OWNER: Downtown Emergency Service Center

The applicant wishes to build a new four story mixed-use building on the site at 10507 Aurora Avenue North. The building will contain 87 residential apartment units on the top three floors. The ground floor will contain approximately 5,000 square feet of restaurant and administrative office space on Aurora Avenue. Common residential space, mechanical space and parking will be located on the ground floor facing the alley.

MAY 9, 2011 . DESIGN REVIEW MEETING DESIGN GUIDELINES

**COURTYARD VIEW**

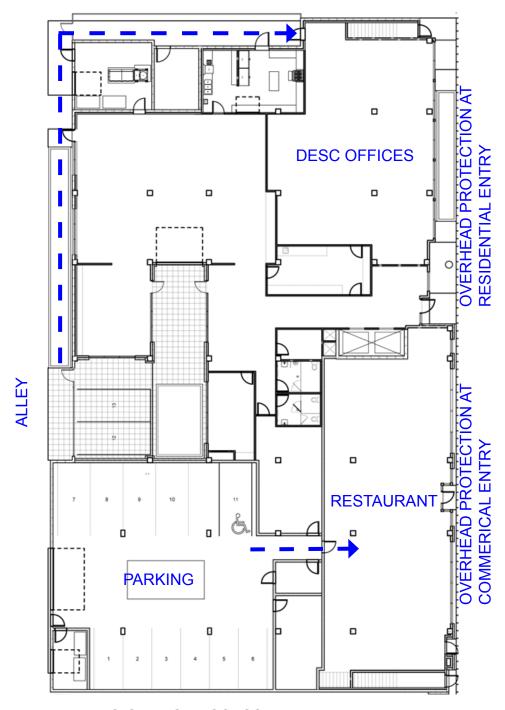
EDG Board Comment: This was seen as one of the primary challenges for the project, providing amenity spaces that addressed needs while also provided comfort and security for the residents.

The project will provide two outdoor recreation spaces for the residents to enjoy. The first will be an enclosed courtyard on the ground floor that will directly connect to the main common areas on the ground floor. The courtyard will be landscaped with shade loving plants like ferns, and will contain a water feature in a storm water planter. Water from the roof will be directed down to the storm water planter on the ground floor where it will run over a rock "waterfall" and into the planter.

The second recreation space will be a rooftop garden. The western side of the building will have a large green roof surrounding a roof deck. The space will be accessible from the fourth floor, and overlooked by a number of residential apartments. This space will be sheltered from Aurora by the mass of the building, and screened from the alley by plantings.

**GARAGE DOOR ON ALLEY**

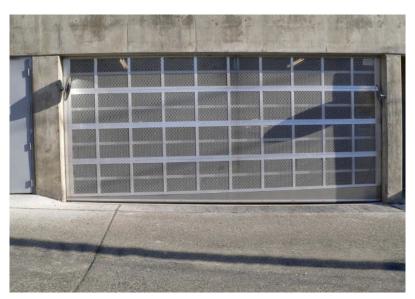
EDG Board Comment: In choosing this Guideline as one of the highest priority, the Board expressed concern for the appearance of the parking garage and its entries from the alley and from across the alley and requested to see landscaping elements that would green the alley-level facade.

All parking along the alley will be enclosed and the garage doors screened. The blank walls will be green walls with vertical growing plants.

ALLEY VIEW LOOKING SOUTH

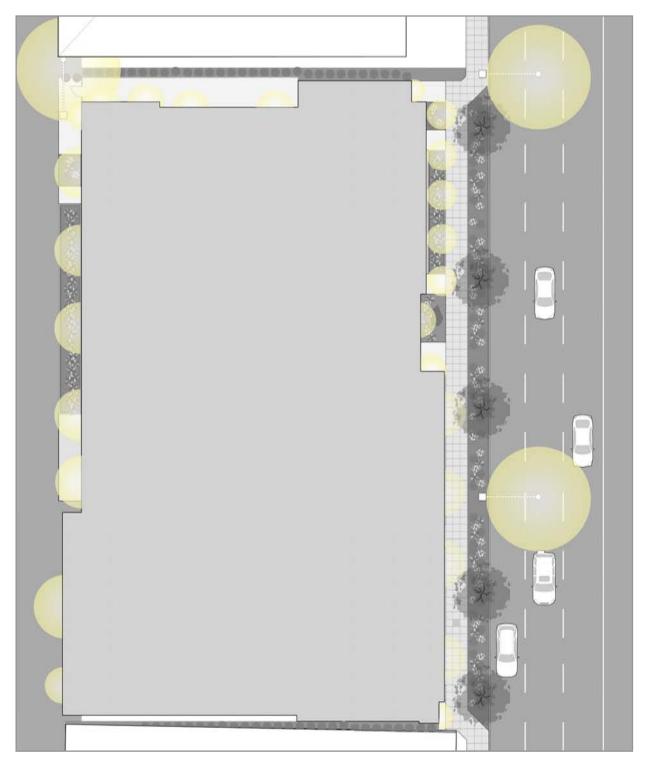
EDG Board Comment: In light of extensive public comments and discussion regarding the safety of the alley, the Board regarded this Guideline to be of particular importance to the design.

On Aurora avenue the reception desk is in the center of the façade to allow building staff to see as much of the street frontage as possible. Building lighting will enhance public safety along the street frontage. The building is built as close as possible to the south property line to eliminate areas for people to hide, while the north property line is fenced with a seven-foot high security fence.

The alley façade will have several large storefront windows from interior common spaces onto the alley. Staff in the reception desk will be able to see through these windows onto the alley. Lighting will also be provided along the alley.

Departure 1: Residential Amenity Space (SMC 23.47A.024B)

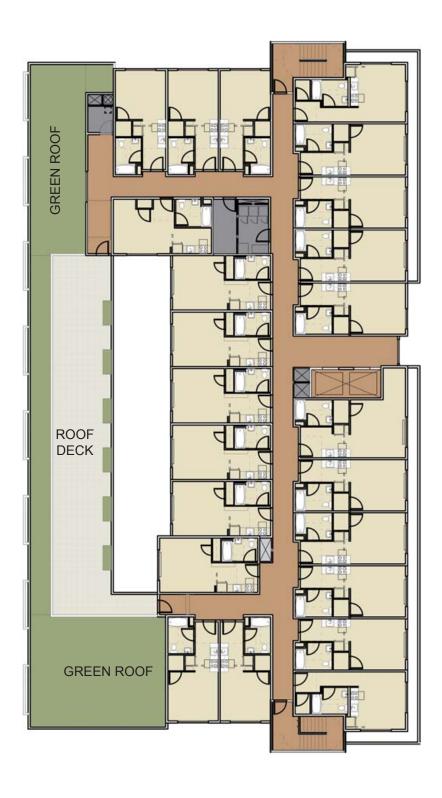
The board indicated they would be favorable toward the departure providing the applicant provides more information regarding the actual design of the spaces and responds to the Board's other requests for a fuller exploration of alternatives and to the Guidelines noted to be of highest priority for the project

The applicant no longer wishes to ask the Board for a departure from the code for amenity space. No departure for residential amenity space is needed. The residential roof deck at level 4 has adequate area to meet the requirements for residential amenity area.
